Cowal Gold Operations Underground Development Modification 1

Optimisation Modification

State Significant Development Modification Assessment
(SSD 10367 MOD 1)

November 2022

Figure 3 | Comparison of the approved and proposed modification footprints

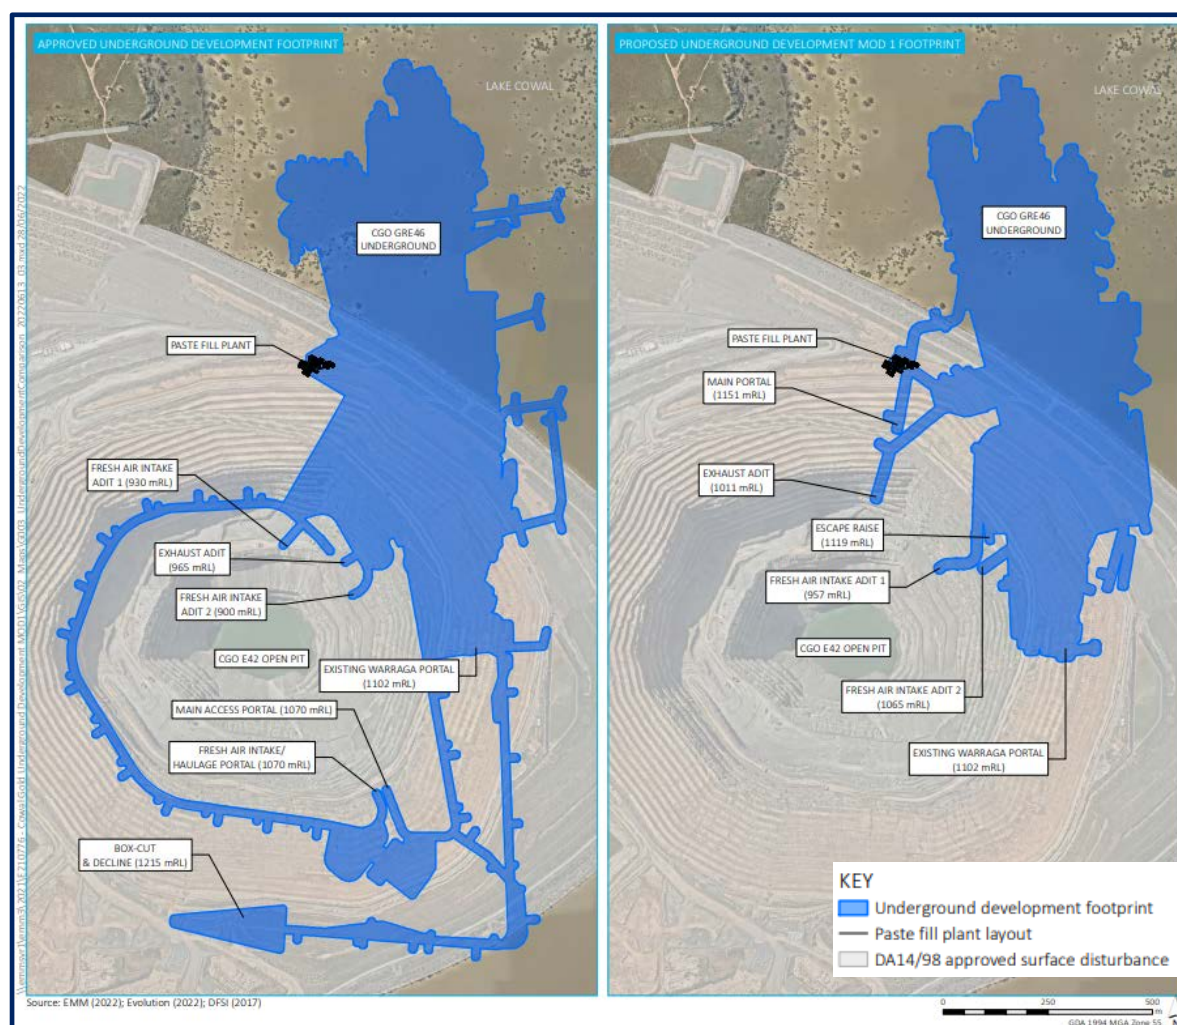
The new portal would take around 2-6 months to construct and construction will involve standard excavation and tunnelling techniques. A comparison of the proposed modification and currently approved underground development footprints is shown in **Figure 3**. There are no proposed changes to the fresh air intake adits or the exhaust adit.

Figure 4 | Comparison of the approved and proposed modification access tunnels

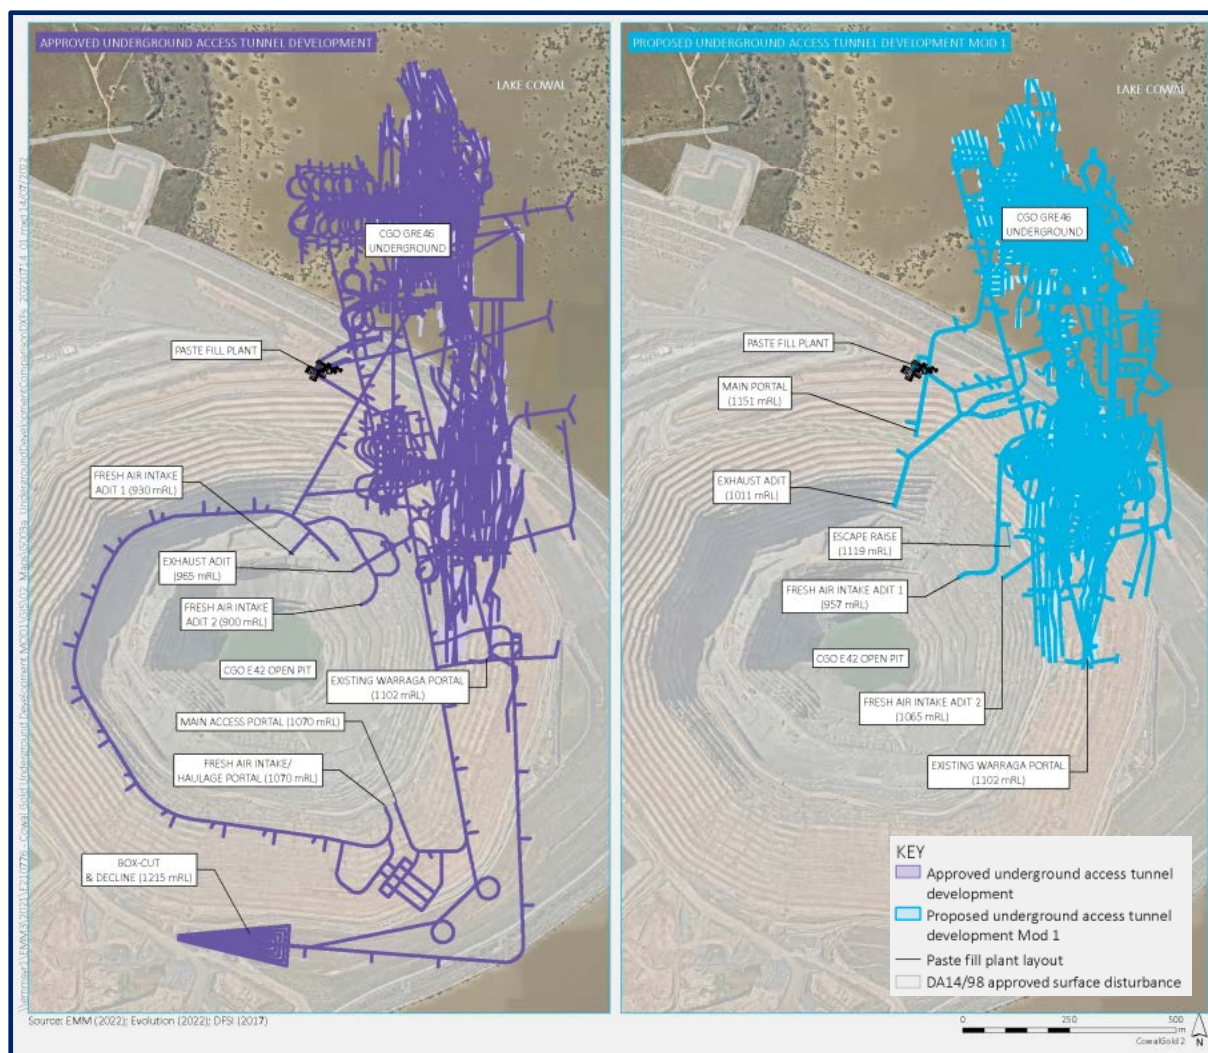
The modification also seeks to modify the location of access tunnels between the development declines and the stoping areas (see **Figure 4**). The key change would be to relocate development tunnels from the western side of the ore body to the eastern side, where they would be below the ore body rather than above it. The proposed location of the tunnels would be more geotechnically stable during

production activities and would also allow for potential future expansion of the current open cut pit as the separation distance between the pit and the tunnels would be larger.
